SERVICE LETTER #48

SUBJECT: New Flap Ratchet.

AIRCRAFT AFFECTED: MAULE Model M-5-220C, Ser. No. 5001C thru 5057C.

SERVICE LETTER # 48
INSTALLATION INSTRUCTIONS

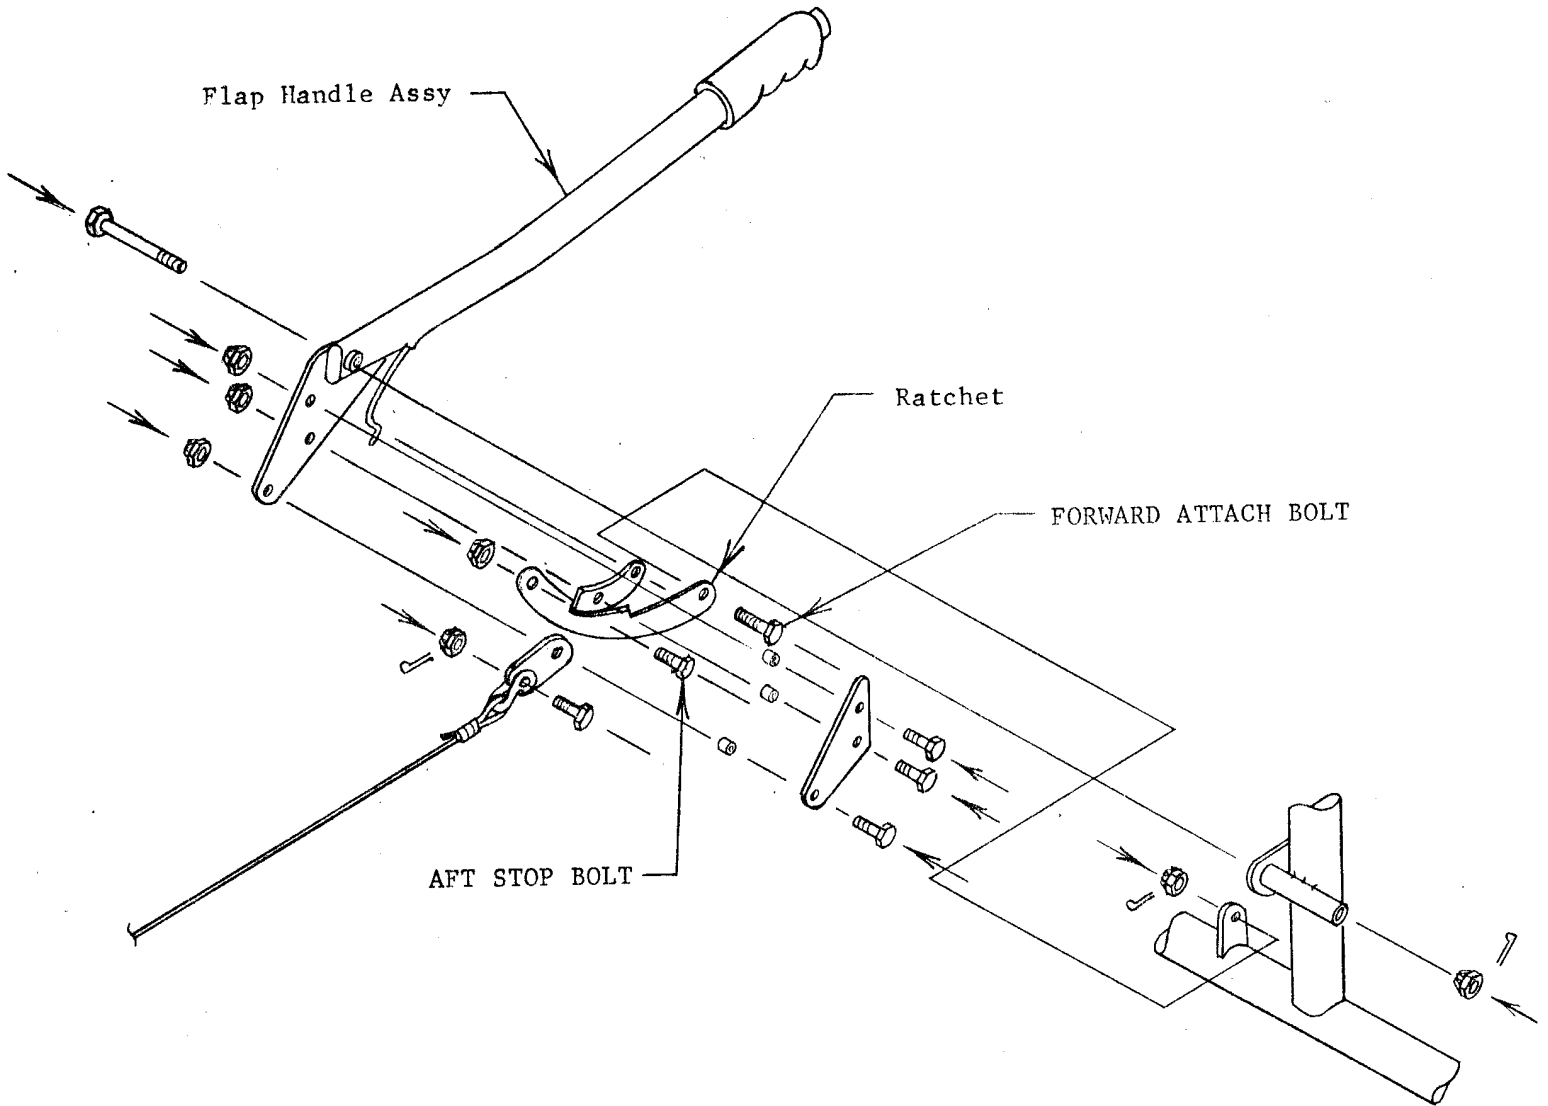
1. Remove left front seat.
2. Remove control cover (ref. Item 6, Group C-4 of Parts Catalog)
3. Remove old ratchet: (See Sketch on page 2)
 - (a) Remove forward ratchet attach bolt and nut.

- (b) Remove aft stop bolt and nut.
 - (c) Slide ratchet forward thru plates of flap handle assembly.
4. Install new ratchet:
 - (a) Slide ratchet aft thru plates of flap handle assembly.

- (b) Install forward attach bolt and nut and secure with cotter pin.
 - (c) Install aft stop bolt and nut removed from old ratchet.
NOTE: 20°-40° ratchet has forward stop bolt and nut deleted.
